MIDWEST POOLED FUND PROGRAM

Progress Report - Fourth Quarter 2010

Midwest Roadside Safety Facility
Nebraska Transportation Center
University of Nebraska-Lincoln

Figure 11. Transition Cap for 32" PCB to the Wisconsin 56" Single Slope Median Barrier

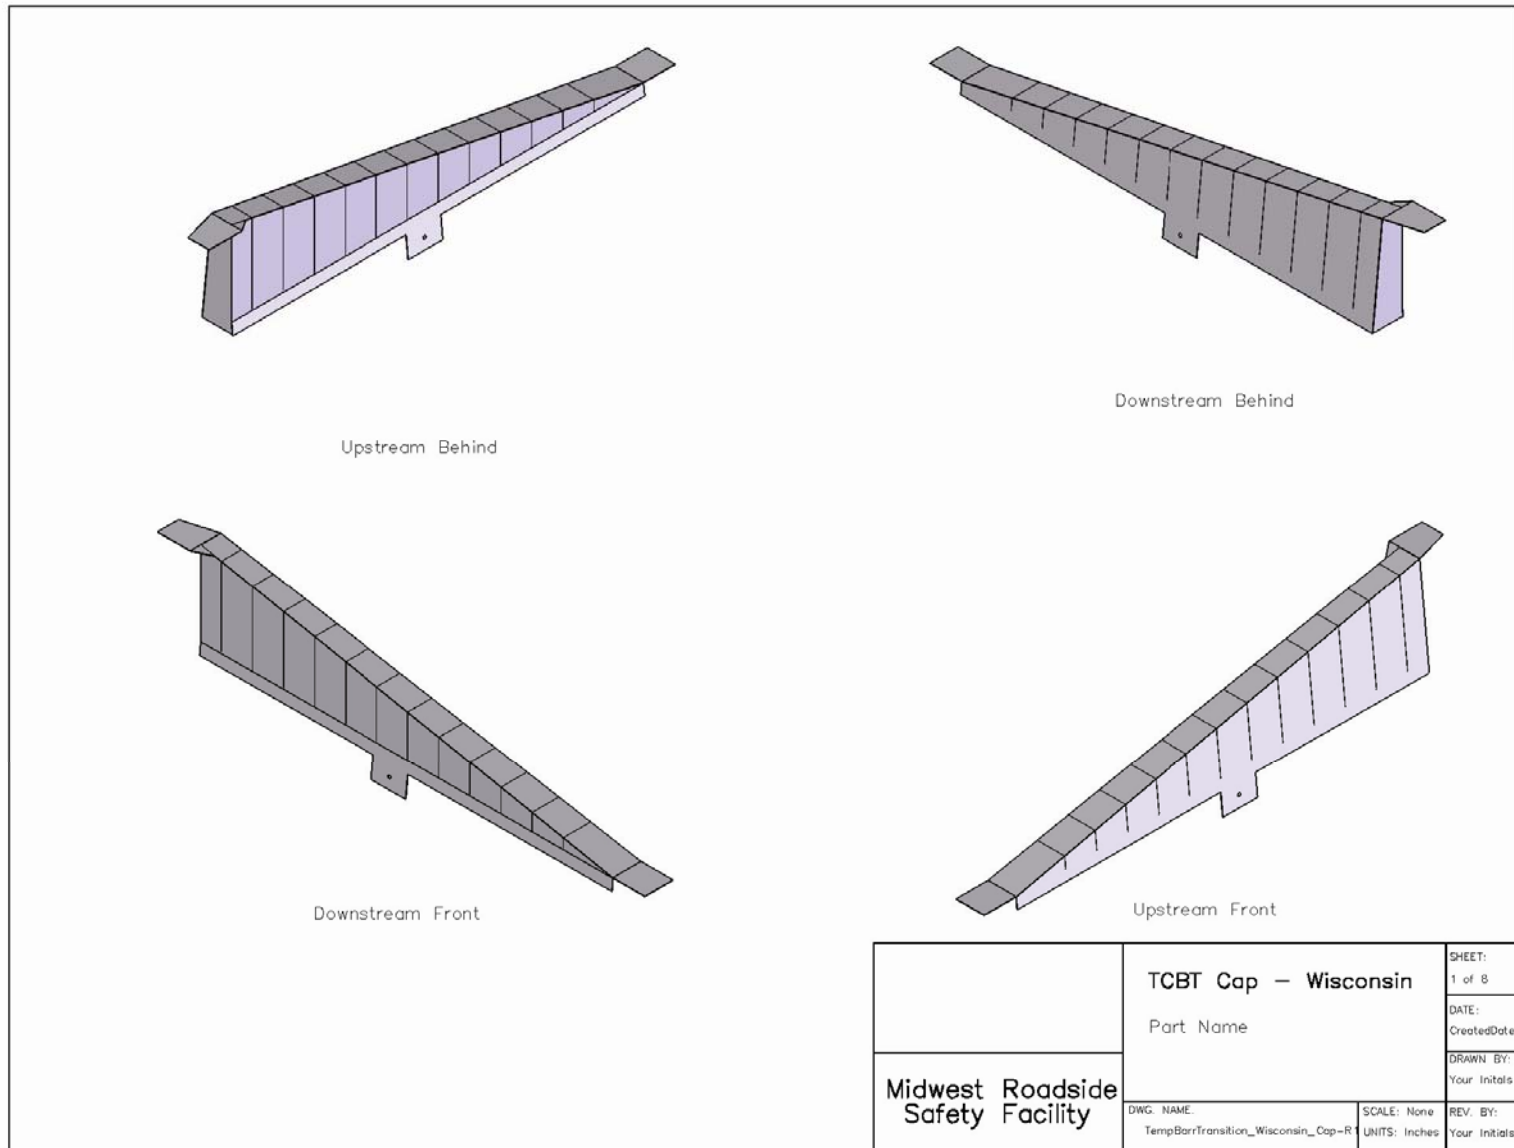
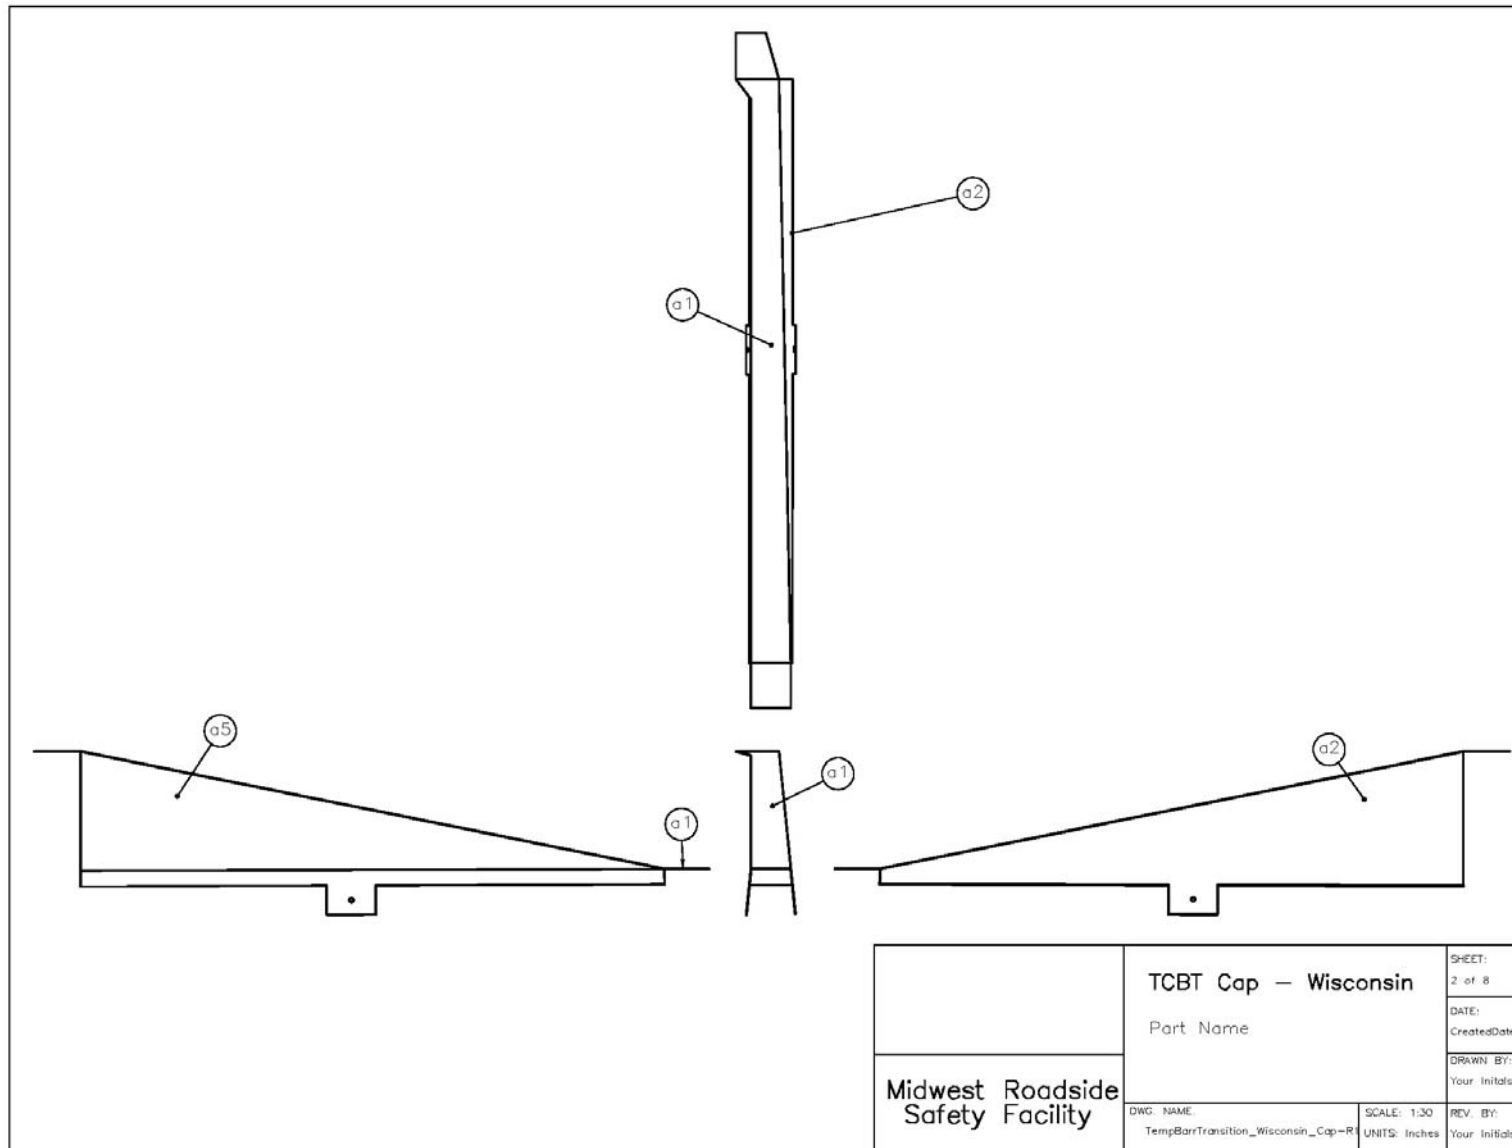
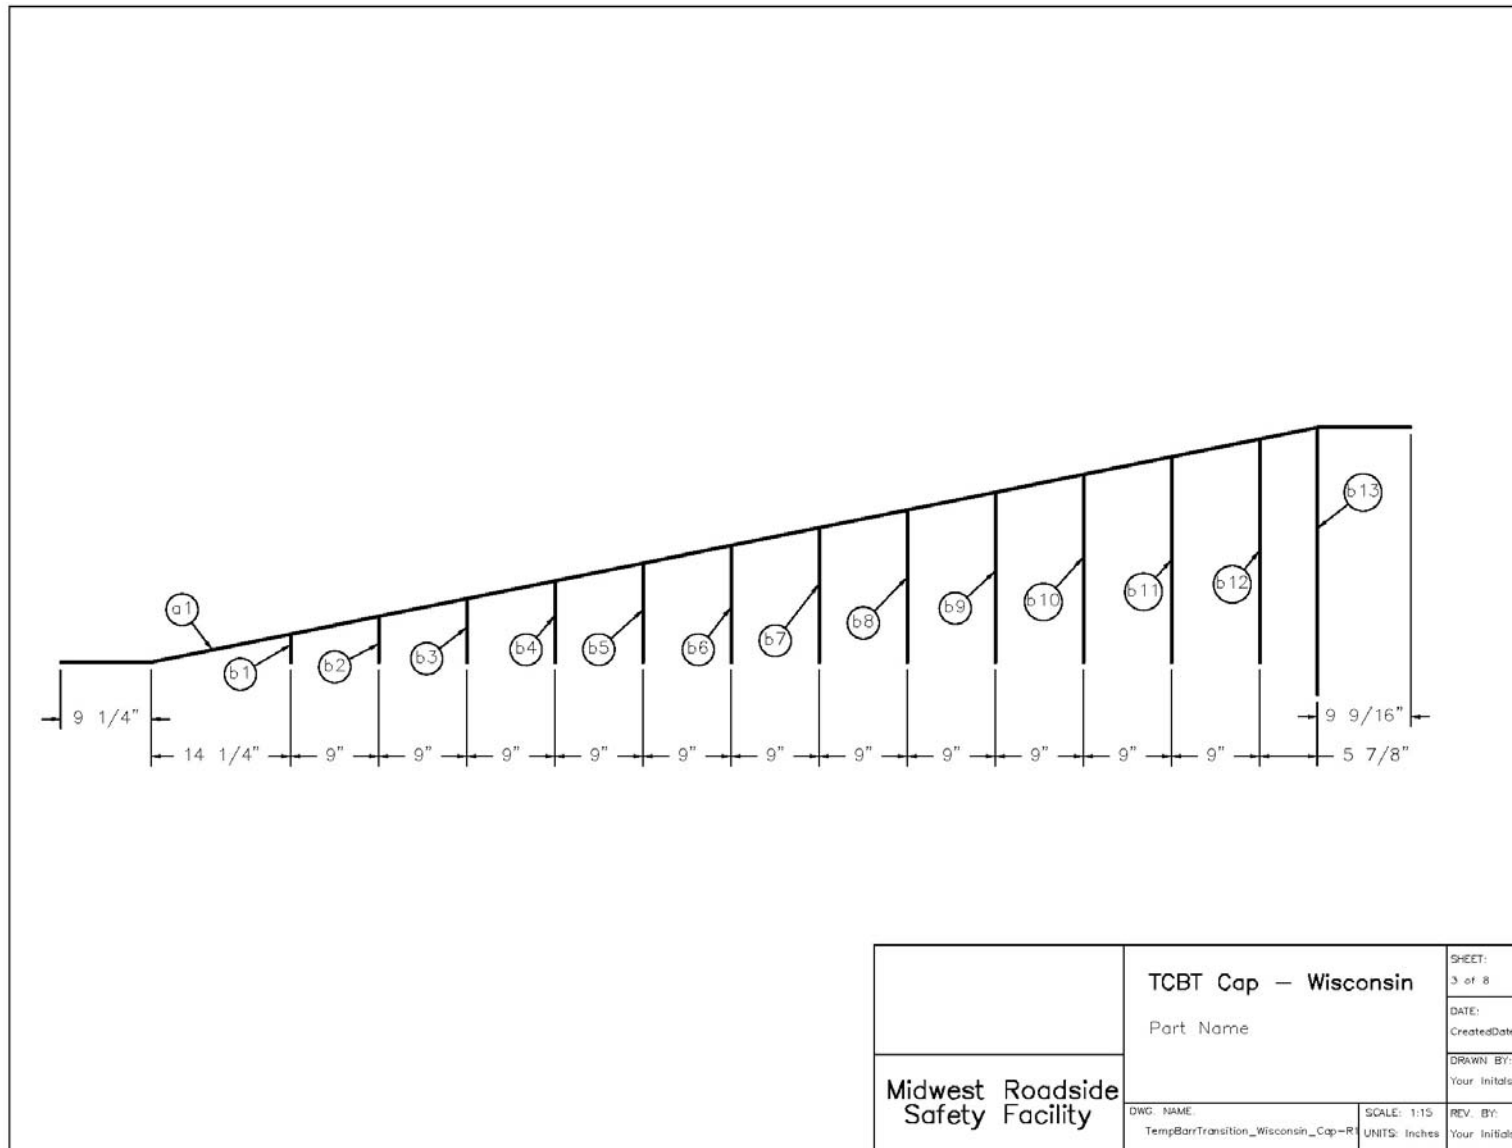
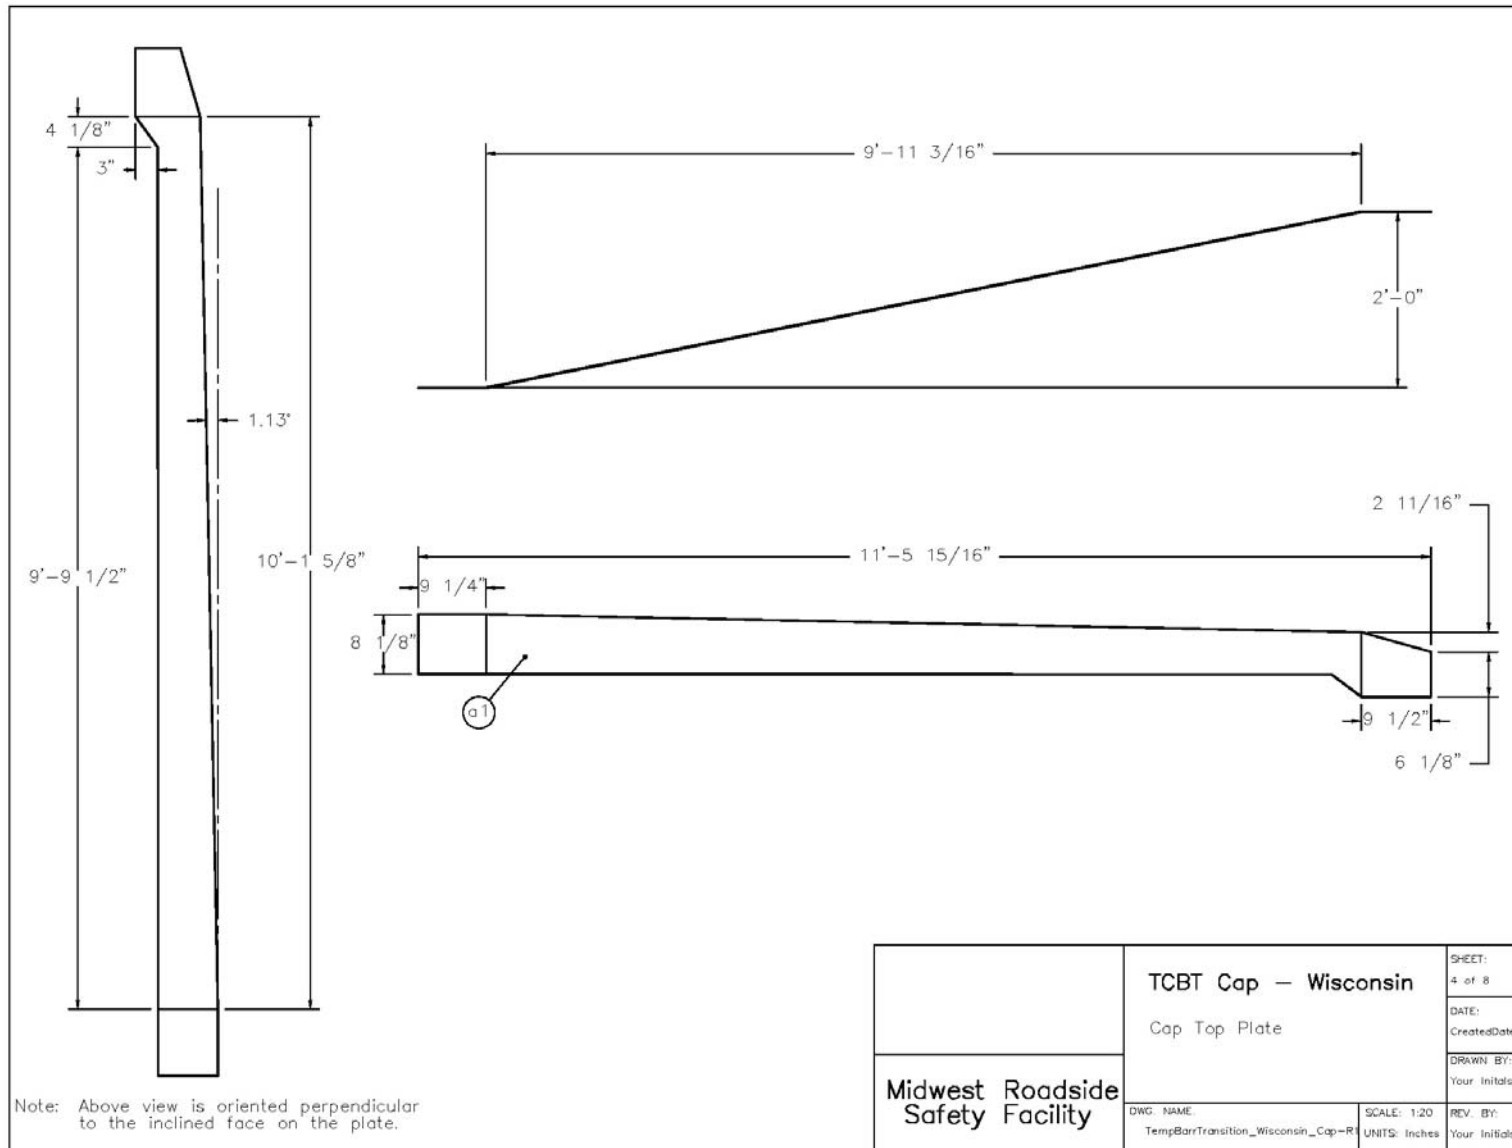
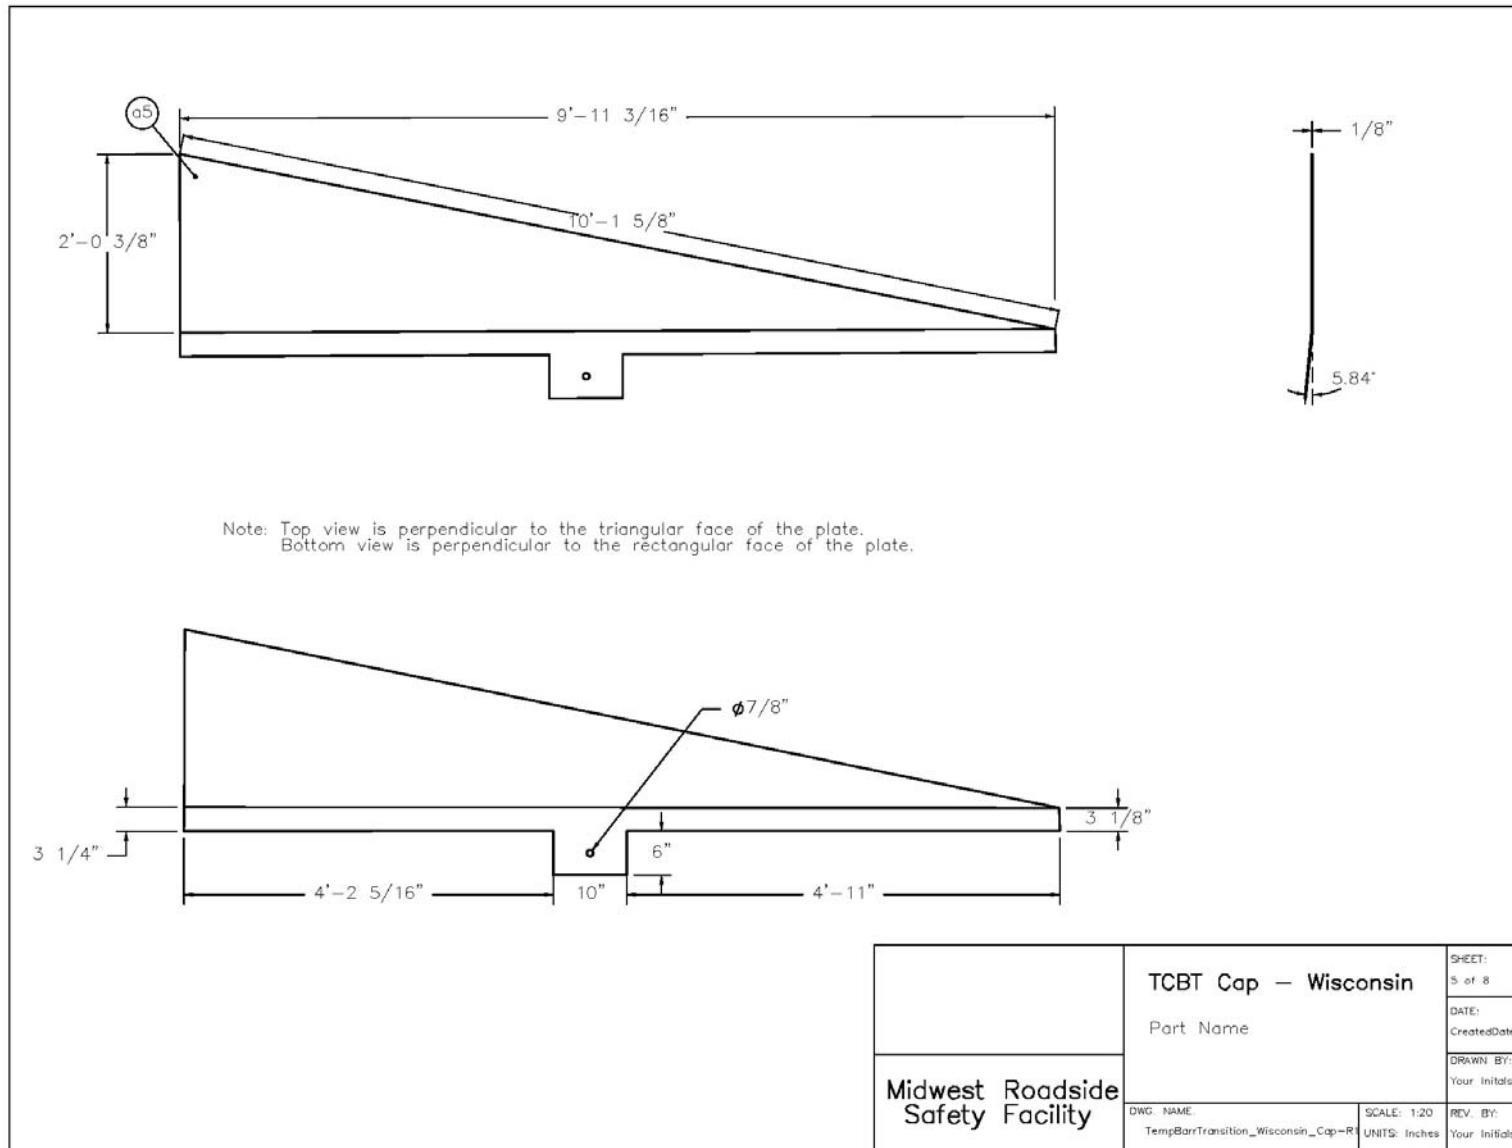
I also looked into your questions regarding the overhanging piece of steel on the TCB median barrier approach transition cap. On the tested system, we designed the cap to match the slope of the sides of the PCB section. Because the tops of the PCB section and the median barrier were not aligned, the cap had an overhanging piece of steel on the oncoming traffic side. This piece is not required for cap designs that match up to barriers of different widths or heights. Changes in the height of the median barrier will require a different cap design. We would require the following.

1. All cap designs use the same vertical slope for the cap as the tested design.
2. The sides of the cap should match the side slope of the F-shape PCB segment.
3. If the cap is longer than the tested cap design, intermediate anchorage should be provided on the side of the cap at the midspan length to provide additional anchorage.

I have attached details for a representative cap for a transition from 32" PCB to the Wisconsin 56" single slope.
